## Determination 2009/96

### The code-compliance of a polyethylene surface water sump at 745 Rosebank Road, Avondale, Auckland

**Figure 1: Elevation of the sump**

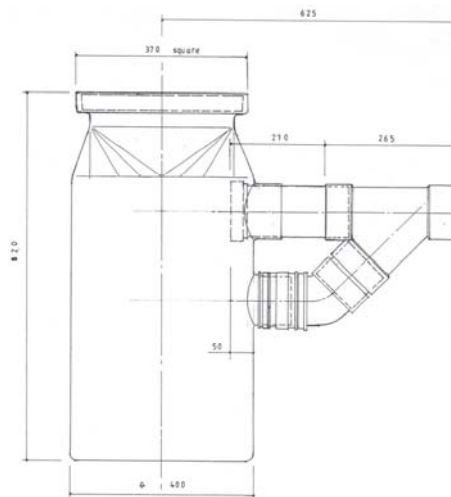
4.11 The authority also accepted the draft, but in a letter to the Department dated 6 October 2009 noted that the sump referred to in figure 1 differed from the model referred to in the consent documentation (I discuss this in paragraph 7.4). While the authority had no issues with the sump described in figure 1, it had concerns regarding the pipe connections to the sump in the consent documentation.

- 7.4 While I have found that this particular sump is code-compliant, I accept that the sump shown on the consent documents may not be. Accordingly, I am of the opinion that the authority was justified in refusing to issue the consent. The applicant should therefore withdraw its original consent application and make a new application based on the sump shown in Figure 1.

- the surface water sump, as described in this determination and in this particular location, complies with Building Code Clauses B1 and E1
- the surface water sump as described in this determination complies with Building Code Clauses B2, and F2
- the decision of the authority to refuse to issue a building consent for the sump shown on the consented documentation is confirmed.

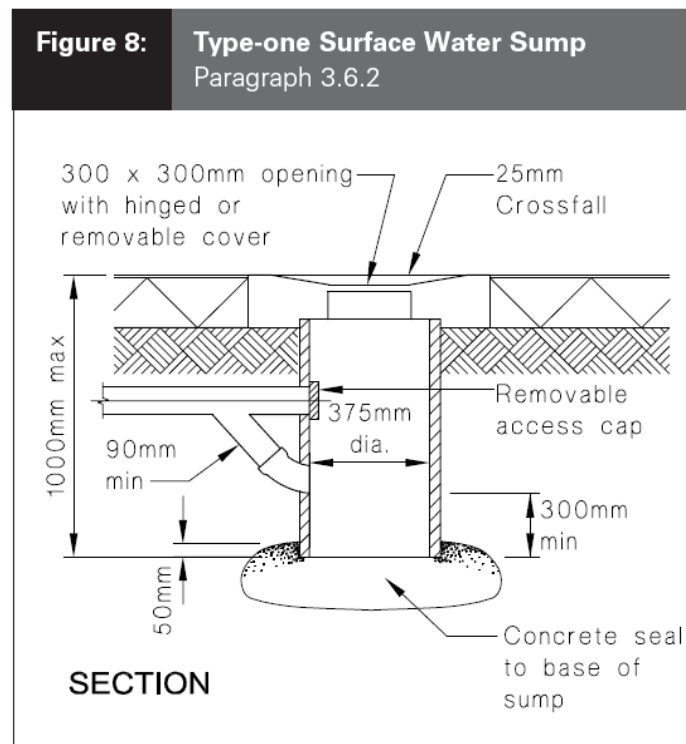
**3.6.2** Two different sumps are shown in Figures 8 and 9. The sump shown in Figure 8 is suitable for an area of up to  $4500/I \text{ m}^2$  ...where I is the rainfall intensity for a storm with a 10% probability of occurring annually.

The relevant figure in this case is figure 8 as shown below.
